Responses to EPC June 11, 2019 Comment Letter:

Transportation / Traffic Impact Study (TIS)

Falcon Marketplace (LSC #164350)

Figure 12

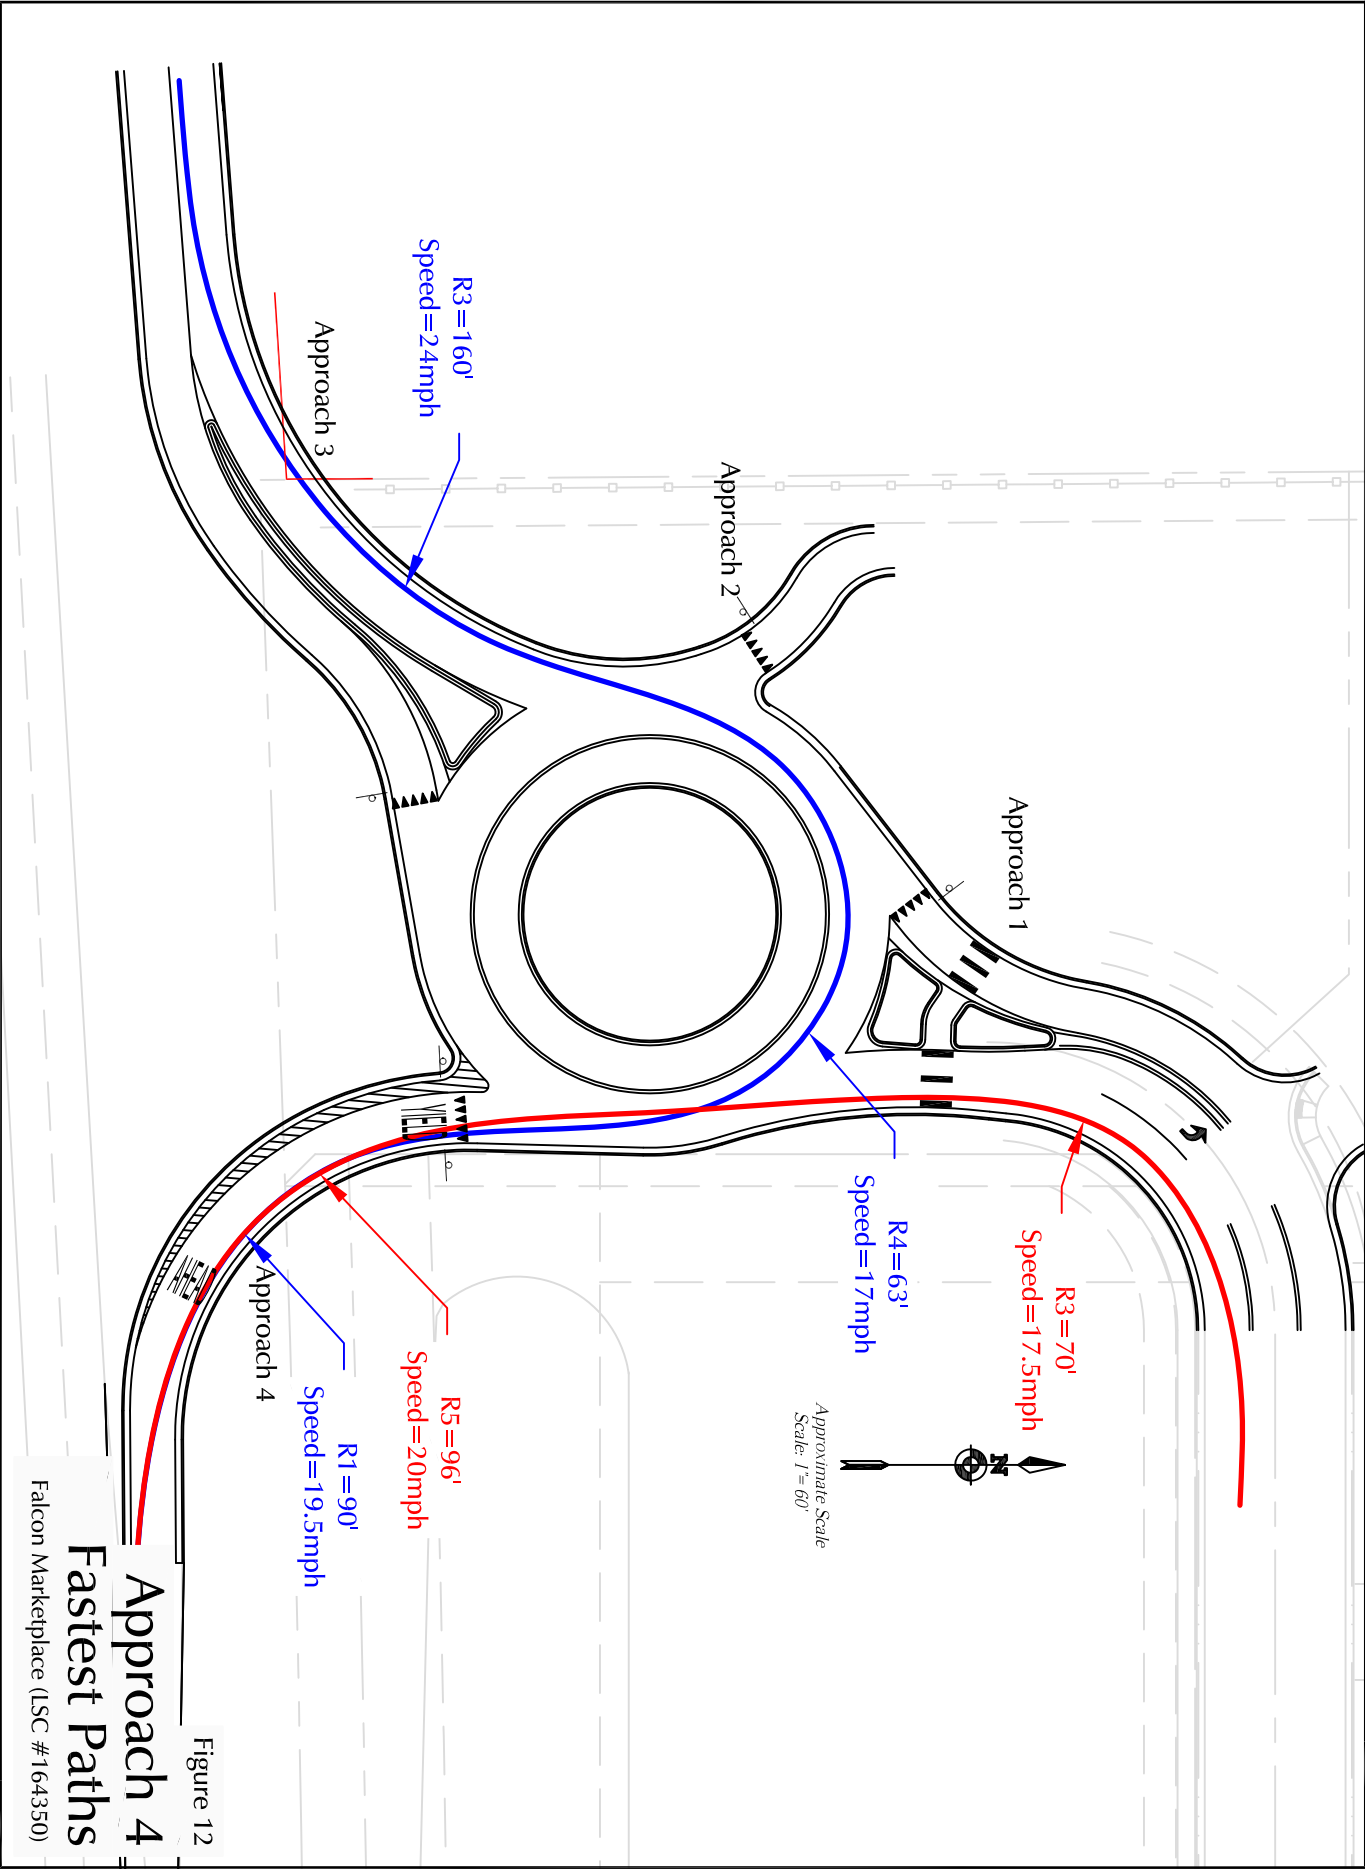
3. *The Phi angle and fastest path combinations are 16 degrees and 22mph for the SW approach, 37 degrees and 25mph for the SE approach (from a parking lot), 17 degrees and 22mph for the NE approach and 16 degrees and 20mph for the NW approach. The recommended fastest path is 25mph and all three approaches with a Phi of less than 20 degrees have fastest paths of between 20mph and 22mph so meet the intent of the Wisconsin DOT guidance provided above.*
